ADDENDUM NUMBER 2

Oak Leaf Trail Phase 4 – Hampton Avenue to Mill Road

Notice Number: 6963

Date of Addendum: March 4, 2015

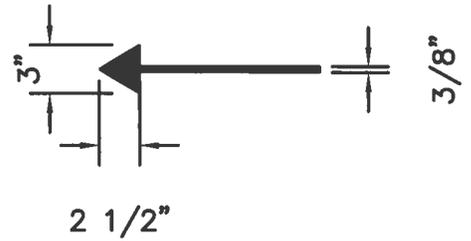
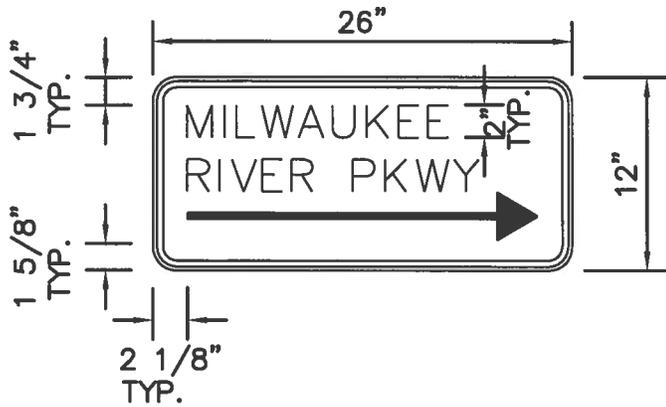
1. Articles 3.8 – Permanent Signing. Item 3.8.B:
 - i) Change number of the total Oak Leaf Trail to nineteen (19) by adding four (4) Oak Leaf Trail signs with arrow pointing right.
 - ii) Correct reference “per F below” to “per G below.”
 - iii) Add the following way finding signage. Way finding signage details attached to the addendum:
 - Two (2) Milwaukee River Pkwy (1 with arrow left and 1 with arrow right)
 - Two (2) Silver Spring Dr. (1 with arrow left and 1 with arrow right)
 - One (1) Mill Rd. (with arrow right)
 - One (1) Sidney Pl. (with arrow left)
 - Two (2) Hampton Ave. (no arrow)
 - Two (2) Lydell Ave. (no arrow)
 - iv) Payment for the additional signage identified in this addendum shall be included in Bid Item 33 – Install permanent trail, warning and regulatory signage.

1. Install way finding signage at cross streets (Hampton Avenue, Lydell Avenue), ramps (Milwaukee River Pkwy, Silver Spring Drive) and at the end of the trail improvements (Mill Road and Sidney Place) at location designated by Owner.

- NOTES: 1. PROVIDE 2 SIGNS FOR LYDELL, HAMPTON, SILVER SPRING AND MILWAUKEE RIVER PKWY. INDIVIDUAL SILVER SPRING AND MILWAUKEE RIVER PKWY SIGNS SHALL HAVE ARROW POINTING OPPOSITE DIRECTION.
2. CENTER TEXT FOR HAMPTON AND LYDELL SIGNS

3. SIGN LETTERS (2" HT.) ARE WHITE; SIGN FACE IS GREEN. BORDER IS WHITE. BORDER IS 3/8" THICK AND 1/4" FROM SIGN EDGE.
4. SIGN POST IS 4"x 4" PRESSURE TREATED LUMBER.
5. PITCH TOP OF SIGN POST AT 2% SLOPE AWAY FROM SIGN.
6. ALL SIGNS ARE ALUMINUM, AND SHALL COMPLY WITH SECTION 637, SIGNING, WDOT STANDARD SPECIFICATION FOR ROAD AND BRIDGE CONSTRUCTION.
7. SIGN IN TYPE II- TYPE H REFLECTIVE- REFERENCE WIS. DOT STANDARD SPECIFICATION FOR ROAD AND BRIDGE CONSTRUCTION LATEST EDITION.

DETAIL C

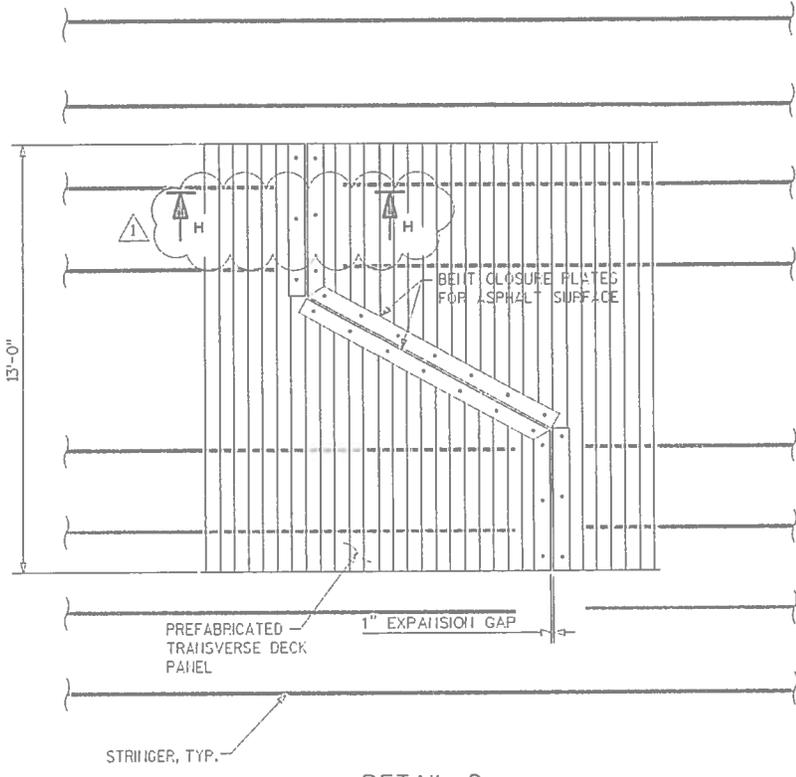
2. Sheet 44 of 56 (C-5): Correct the section reference on Detail C to indicate section H-H per attached revised plan sheet.
3. Provide Deterrent 6' High Chain Link Fence at both ends of each Bridge A and Bridge B shown on the attached map. The two bridges are located near Station 144+22.56 at the end of the trail improvements. The entire width of each bridge approach shall be barricaded using 6' chain link fence. Run chain link fence a minimum 10' beyond the width of the bridge down each side of the railroad embankment. Payment for Deterrent 6' High Chain Link Fence will be by the Lump Sum for each bridge.

DATE:	1-23-15	REVISION DESCRIPTION:	CORRECTED SECTION CUT
BY:			KGW

NOTE
- FOR SECTION G-G (AND H-H, SEE SHEET C-4)
